Village of Bayside
9075 N Regent Road
Architectural Review Committee Meeting
May 24, 2021
Remote Teleconferencing, 6:00pm

**ARCHITECTURAL REVIEW COMMITTEE
AGENDA**

VILLAGE CODE REVIEW

PLAT OF SURVEY

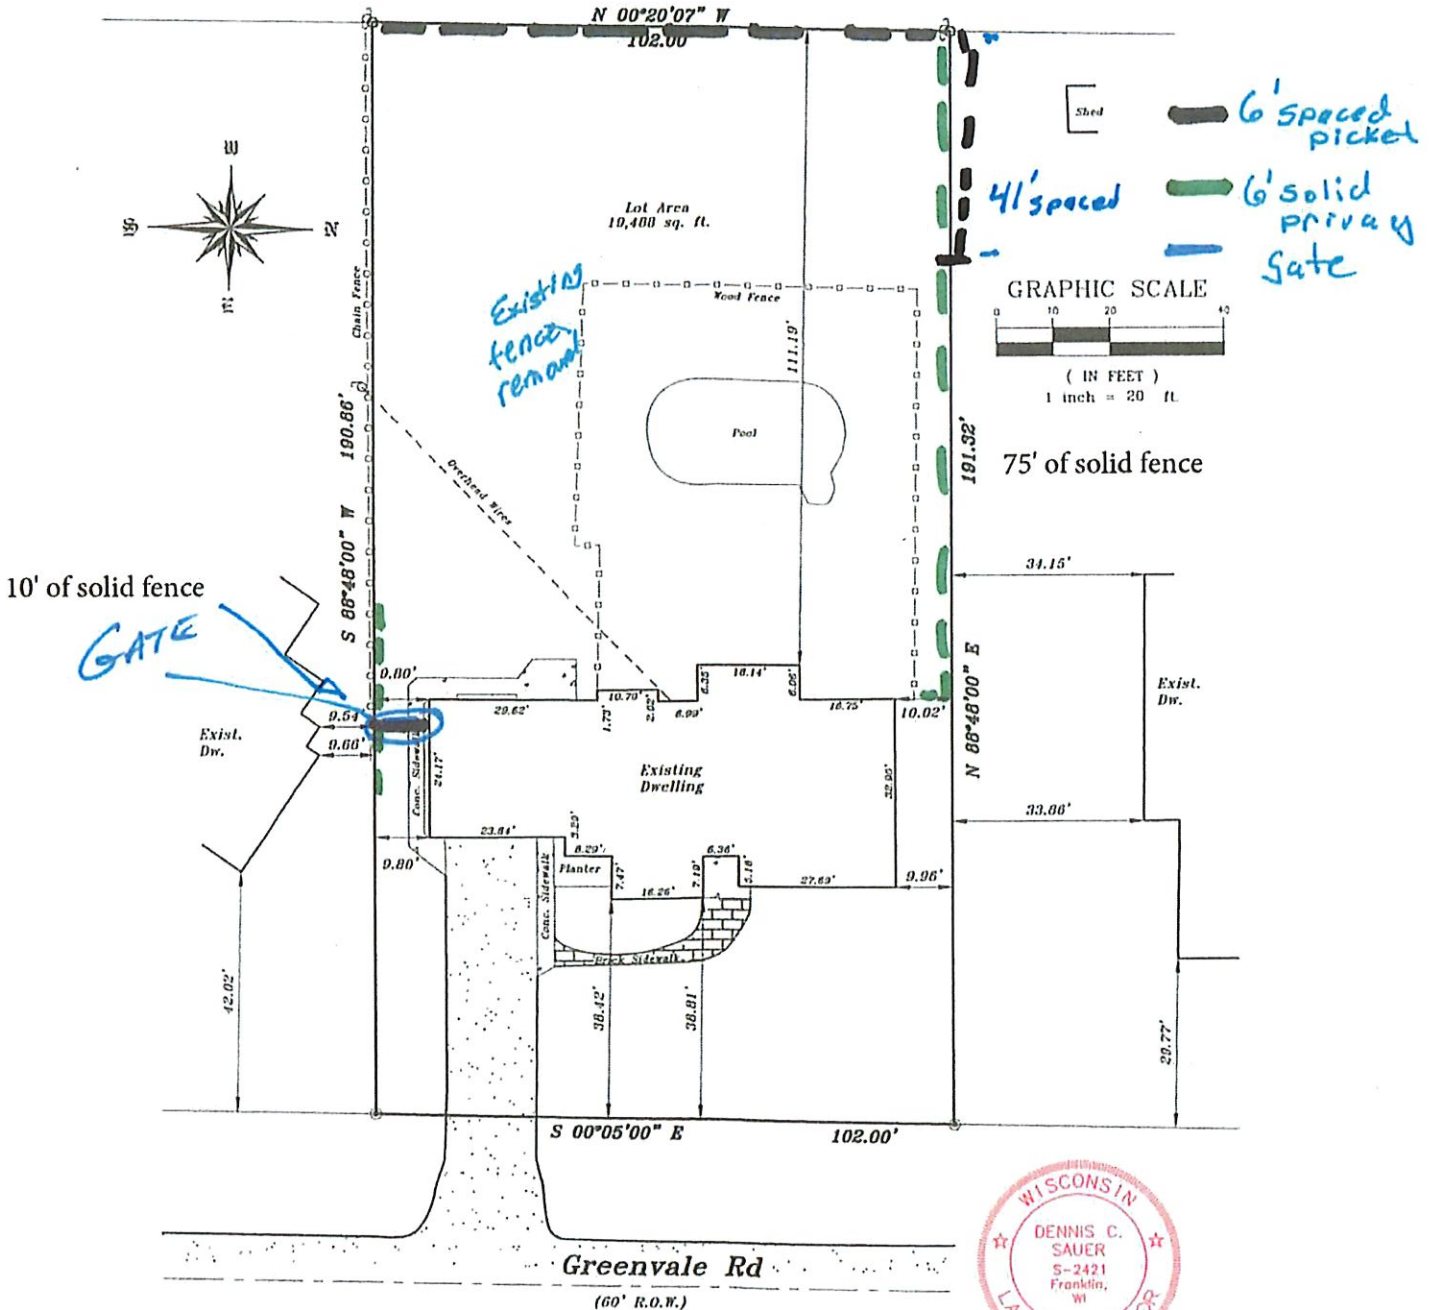
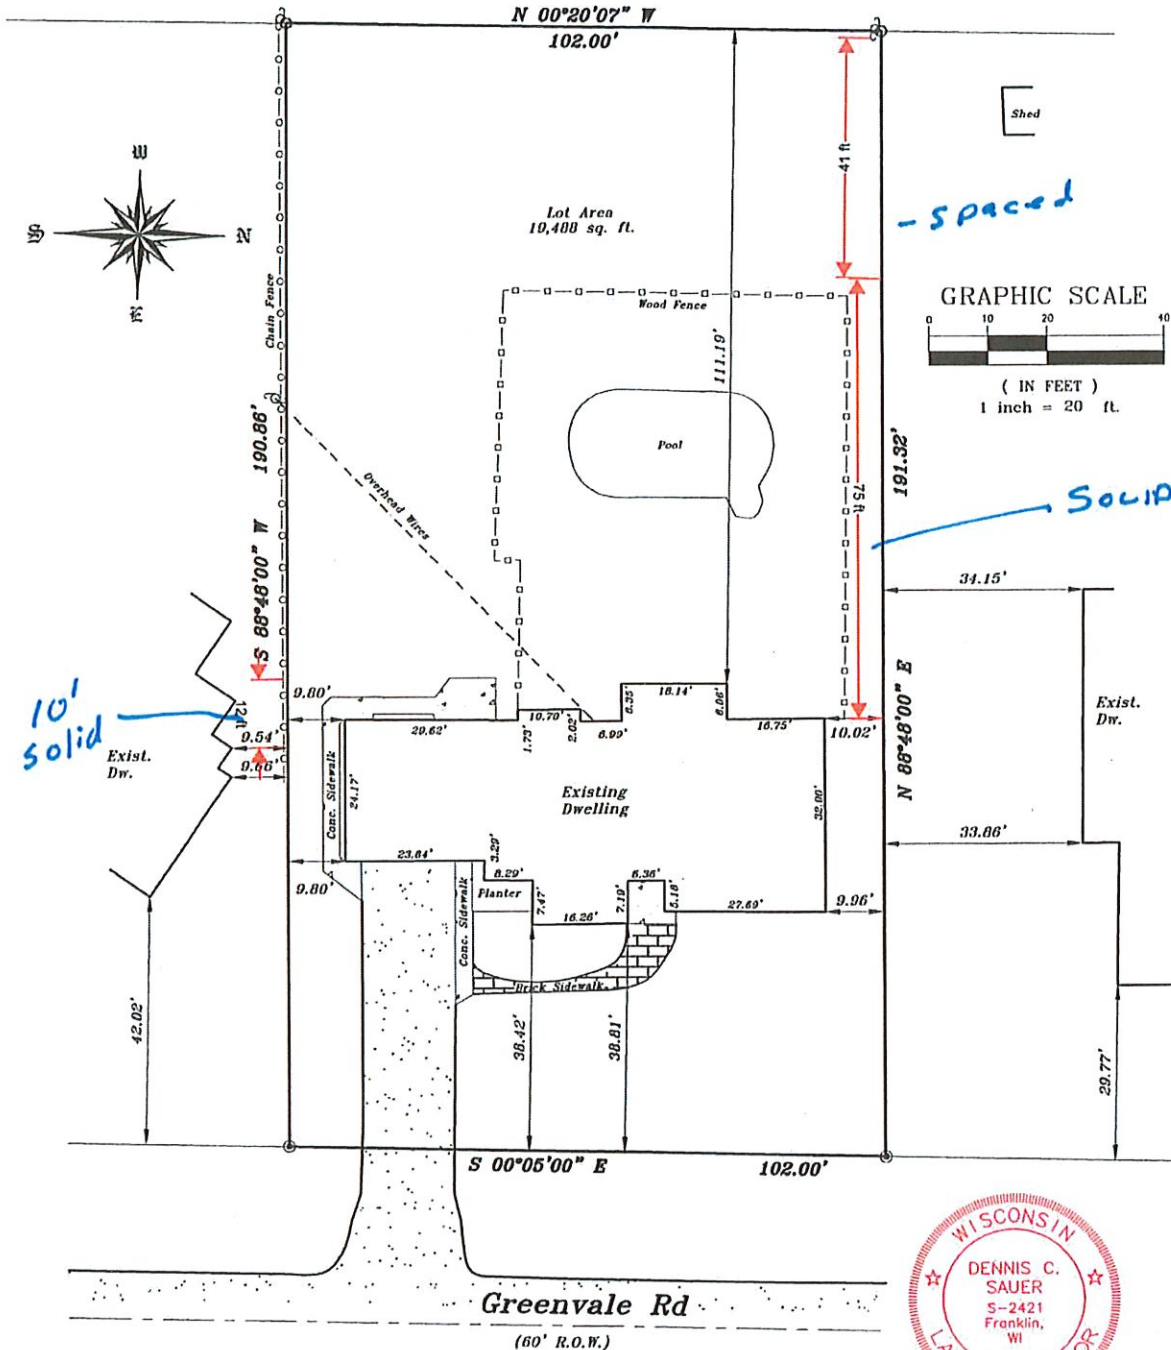
Proposed length 220' is approximately 38% of the total property perimeter length of approximately 585'.
Per the code section copied below a 25% open fence is required.
The proposed 85' of solid fence does comply with the referenced code.

PROPOSED FENCE LENGTH OF SOLID AND OPEN PORTIONS ARE COMPLIANT

This is based of a revised survey
The application shows a different length for the solid fencing

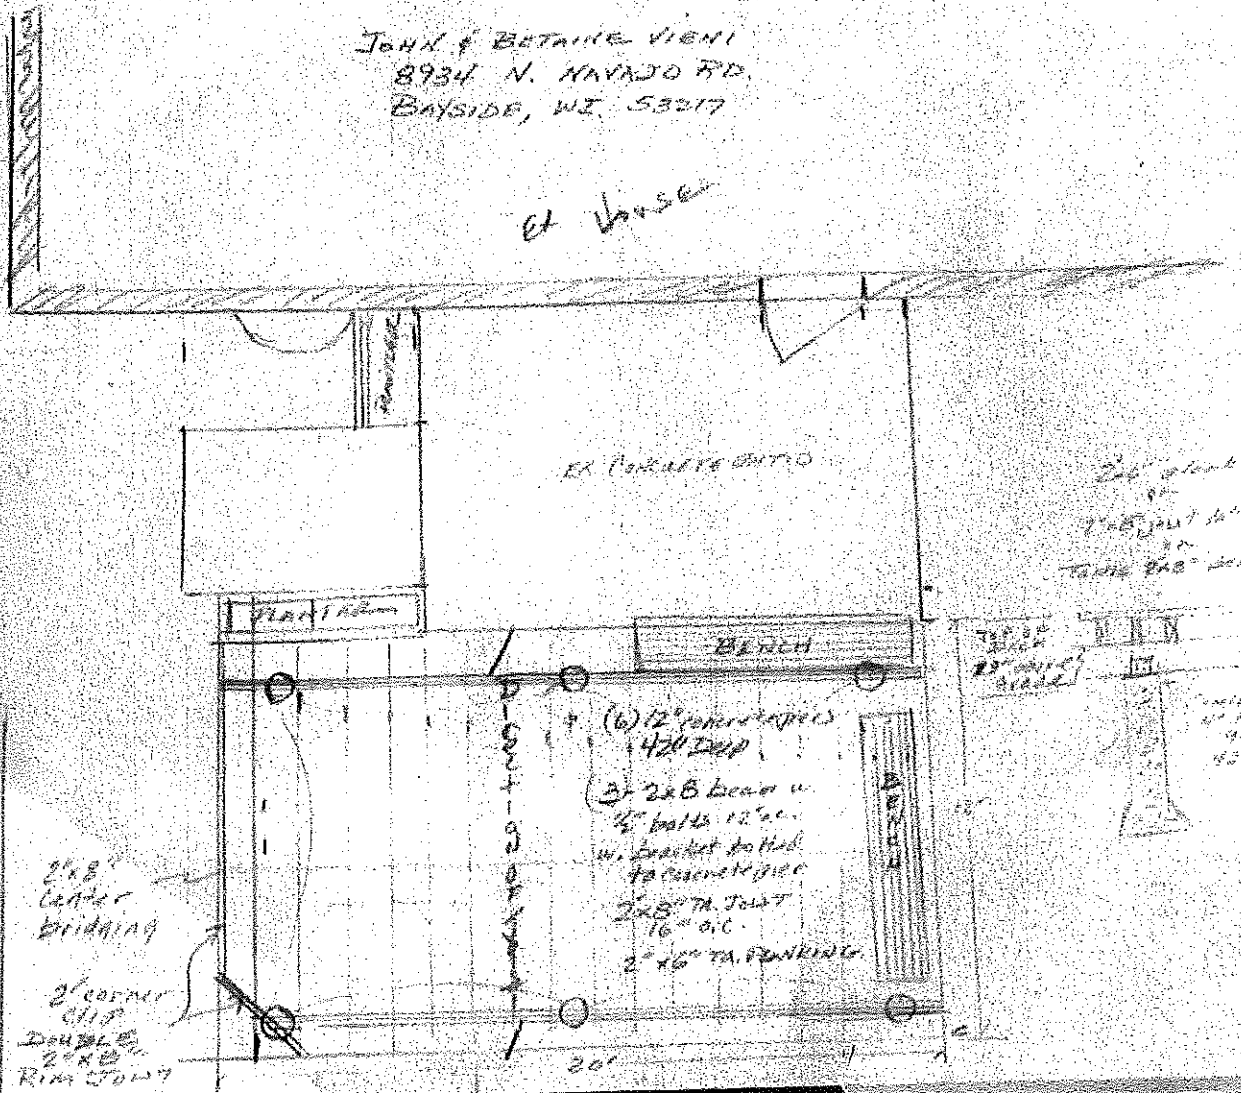
(m) Decks or patios are not considered accessory structures but shall not exceed 18 inches in height and 150 square feet without the approval of the architectural review committee.

Setbacks are code compliant

Building review is required. Submit complete set of construction plans for review before a building permit will be issued

PROJECT NAME: SCHLITZ AUDOBON, JASON
 PROJECT SITE ADDRESS: 1111 E BROWN DEER RD
 BAYSHIRE, VT - MILWAUKEE COUNTY
 BUILDING SIZE: 506x413'-8"
 SHEET NAME: FLOOR PLAN

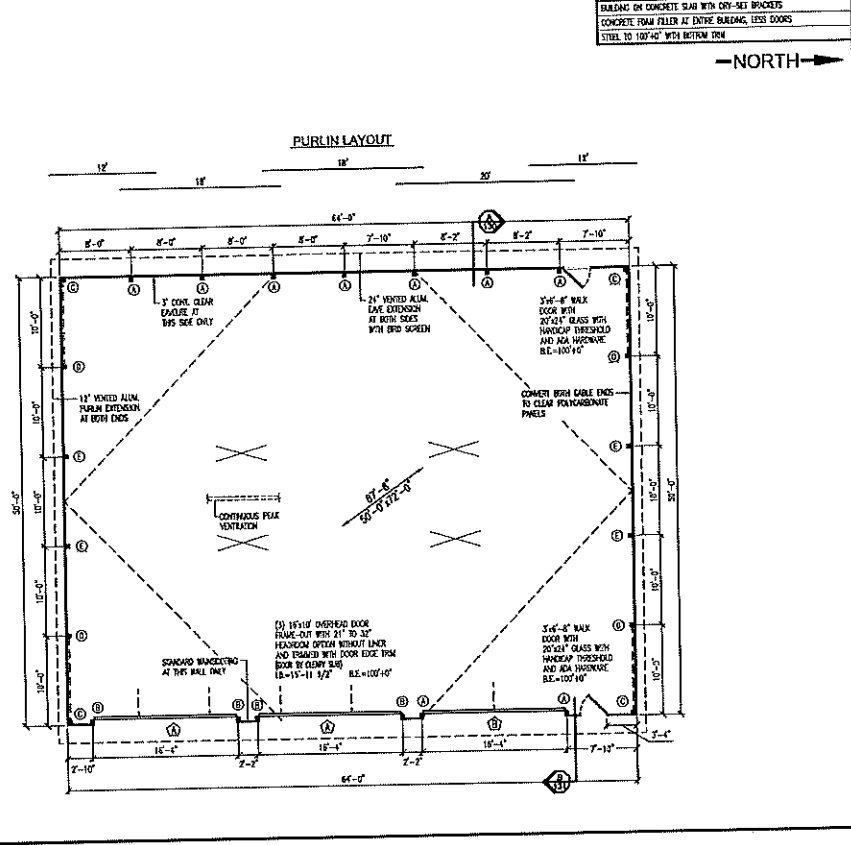
Architectural Review Committee shall make the final determination for approval of the proposed roof design relative to the existing nearby structures.

Building review is required. Submit plans with a completed SBD – 118 plan review application form.
